October 3, 2022

**Re: Fliz Drinks**  
**Corner of Cottonwood Dr. and Old Airport Rd. NW**  
**Traffic Circulation Layout**  
Architect's Stamp xx-xx-xx (A14-D049)

Based upon the information provided in your submittal received 09-14-22, the above referenced plan cannot be approved for Building Permit until the following comments are addressed:

ENGINEER'S SEAL	FIIZ DRINKS ALBUQUERQUE, NM	DRAWN BY JL
	TRAFFIC CONTROL LAYOUT	DATE 7-14-22
RONALD R. BOHANNAN P.E. #7868	 TIERRA WEST, LLC 5571 MIDWAY PARK PL NE ALBUQUERQUE, NEW MEXICO 87109 (505) 858-3100 www.tierrawestllc.com	SHEET # F-1
		JOB # 2022048

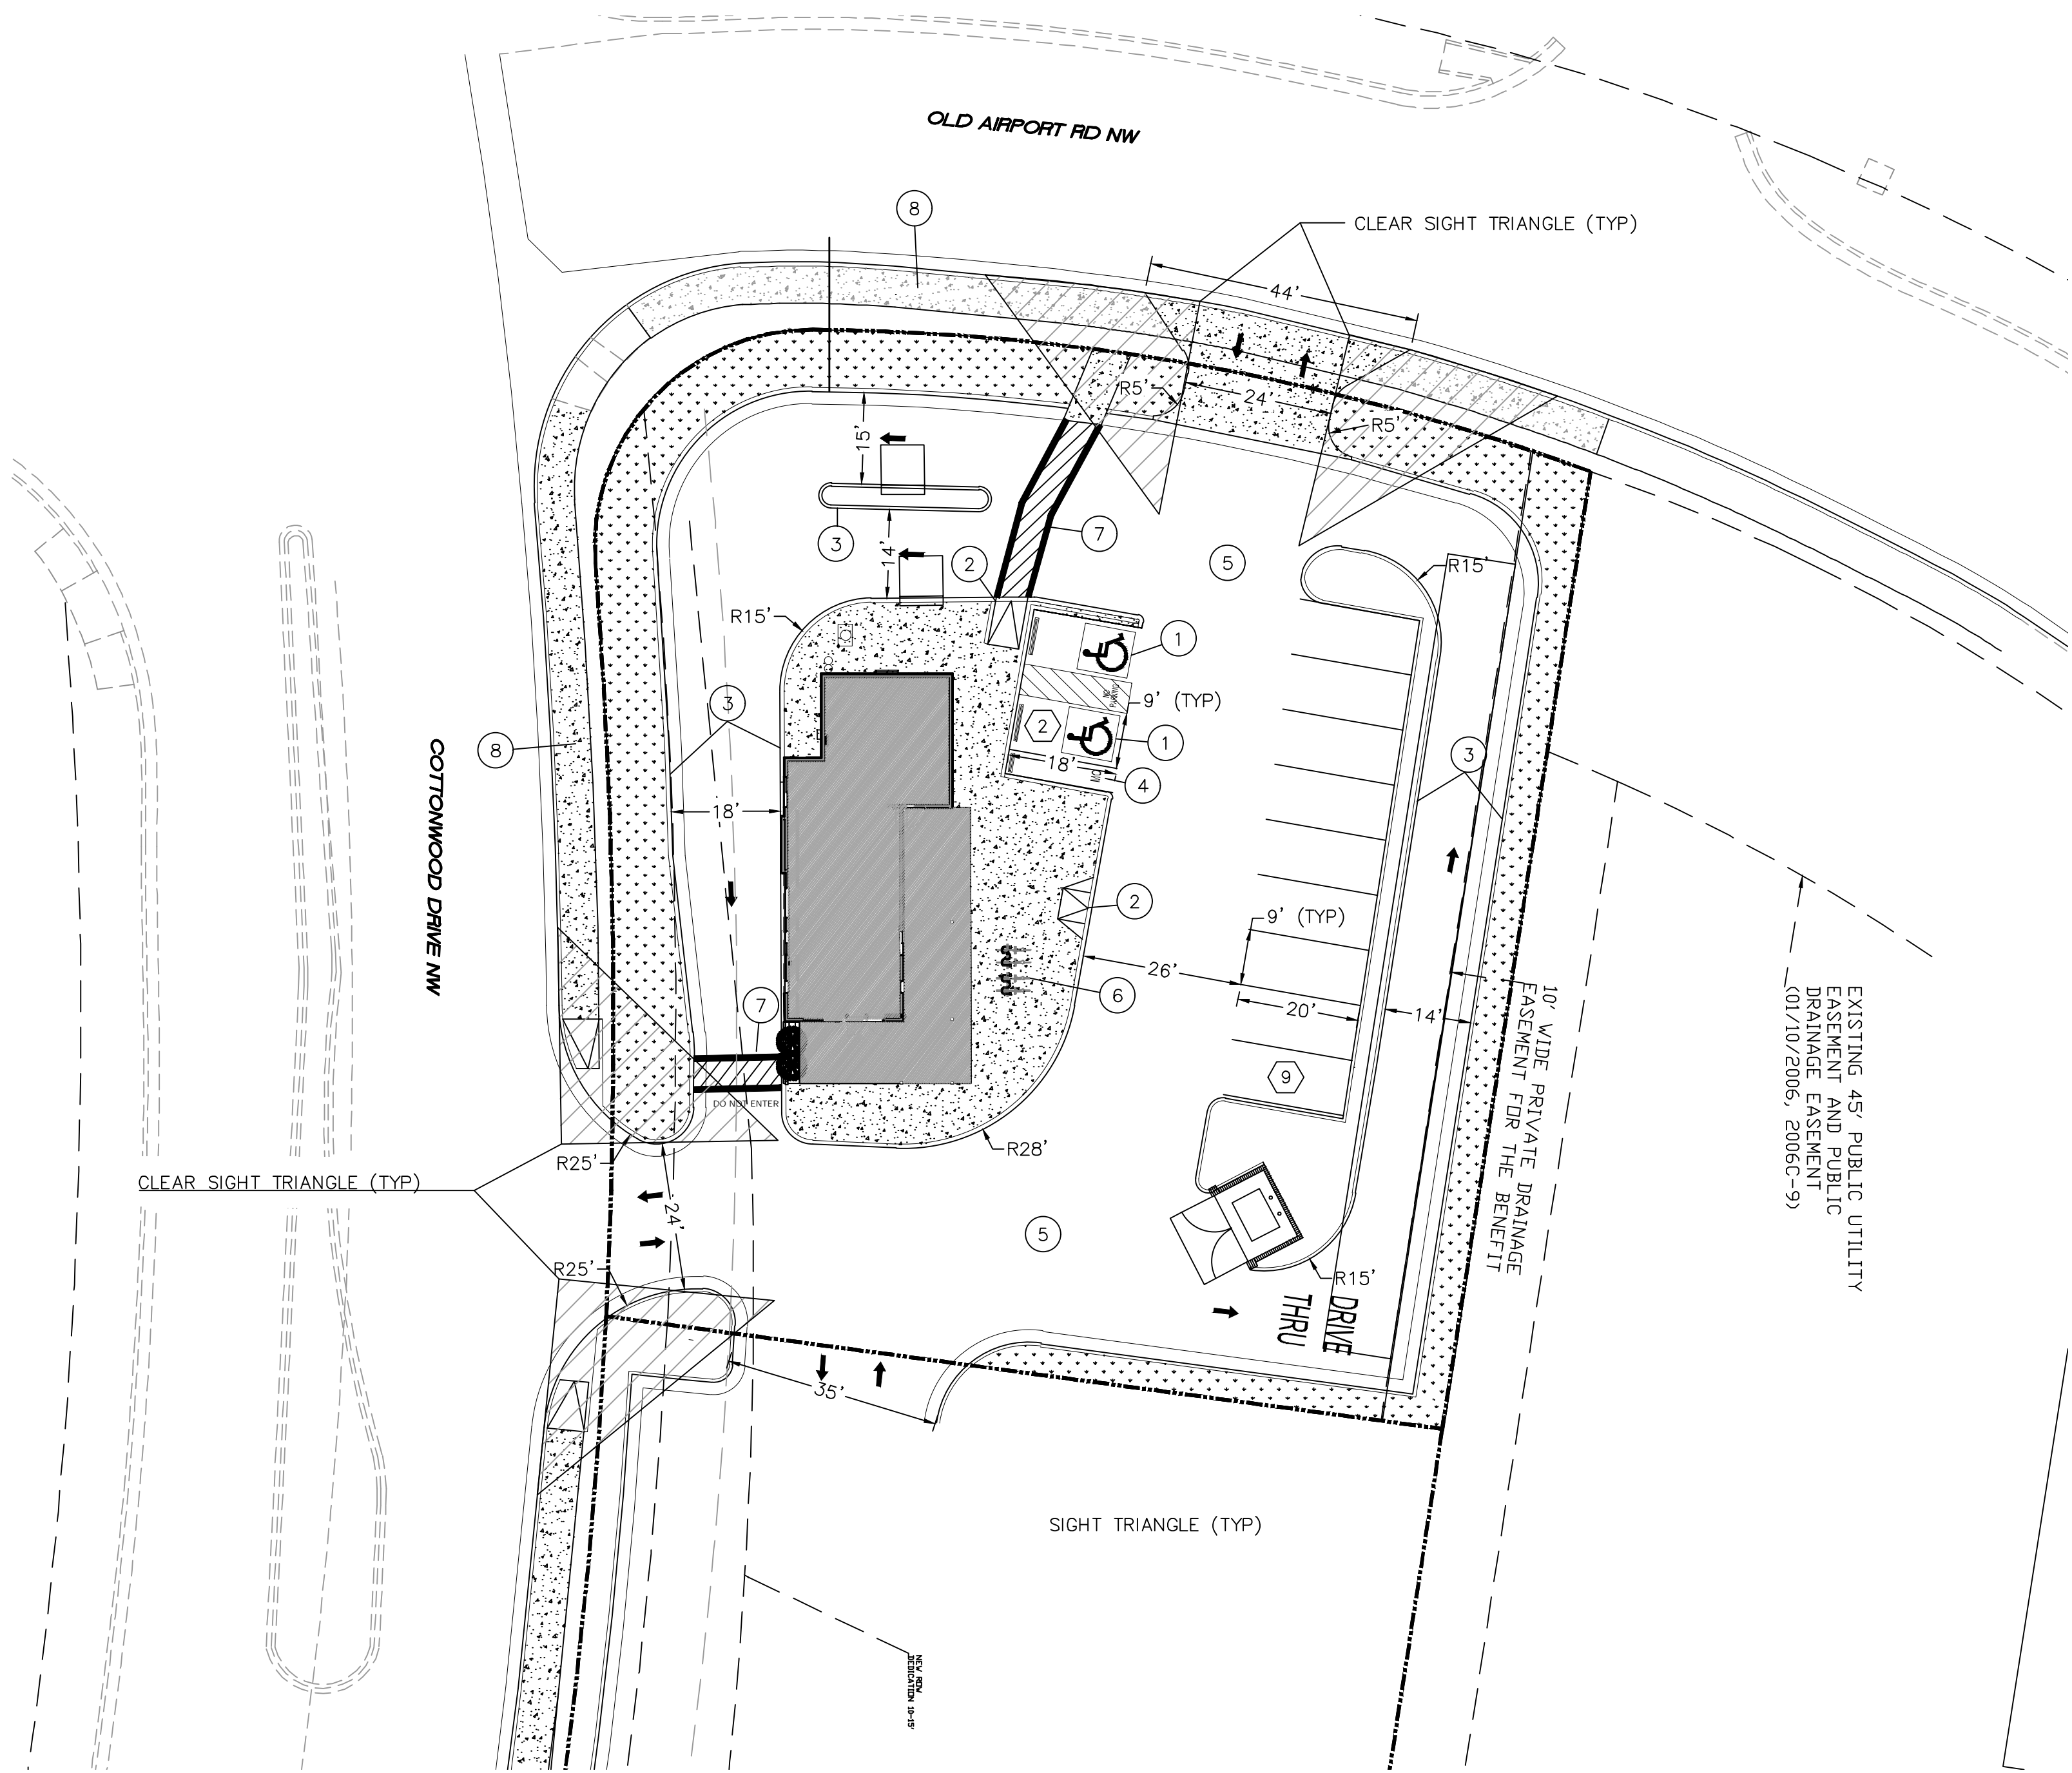
1. The traffic circulation layout must be stamped, signed, and dated by an engineer or architect licensed in the state of New Mexico.
2. Identify the right of way width, medians, curb cuts, and street widths on Old Airport Rd. and Cottonwood Dr.

3. Please provide Curb Return Design for both driveways' accesses of Old Airport and Cottonwood Dr. and reference COA std dwg 2426.
4. The ADA accessible spaces must include an access aisle. Van accessible aisles should be 8ft wide; all others should be 5ft wide.

5. Provide details for the interior ADA ramp.
6. The ADA accessible parking sign must have the required language per 66-7-352.4C NMSA 1978 **"Violators Are Subject to a Fine and/or Towing."** Please call out detail and location of signs.

7. ADA curb ramps at the corner of Old Airport Rd. and Cottonwood Dr. must be updated to current standards and have truncated domes installed. Please clarify if the existing ramp is ADA compliance.

8. Provide Motorcycle parking space's details.
9. All bicycle racks shall be designed according to the following guidelines:
  - a. The rack shall be a minimum 30 inches tall and 18 inches wide.

10. Bicycle racks shall be sturdy and anchored to a concrete pad.
11. A 1-foot clear zone around the bicycle parking stall shall be provided.
12. Bicycle parking spaces shall be at least 6 feet long and 2 feet wide.

13. List radii for all curves shown; for passenger vehicles. Radius for delivery trucks, fire trucks, etc. is 25 ft. or larger.
14. Key note 7: Per the IDO, a 6 ft. wide ADA accessible pedestrian pathway is required from the public sidewalk to the building entrances. Please clearly show this pathway and provide details.

15. Per DPM, a 6 ft. wide ADA accessible pedestrian pathway is required from the ADA parking stall access aisles to the building entrances. Please clearly show this pathway and provide details.

16. ADA accessible pedestrian pathway should not be placed behind parking space or adjacent to a vehicular way. Vehicle and pedestrian/wheel chair conflicts should be avoided as much as possible.

17. Define ADA pathways by labeling of ramps, flush pavement, dimensioning of pathways, doorways, etc.
18. Refuse vehicle maneuvering shall be contained on-site. The refuse vehicle shall not back into the public right of way.; provide a copy of refuse approval.

19. Provide a copy of Fire Marshal approval.
20. Please specify the City Standard Drawing Number when applicable.
21. Work within the public right of way requires a work order with DRC approved plans.

22. Please add a note on the plan stating "All improvements located in the Right of Way must be included on the work order."
23. Add a note stating "All broken or cracked sidewalk must be replaced with sidewalk and curb & gutter." A build note must be provided referring to the appropriate City Standard drawing.
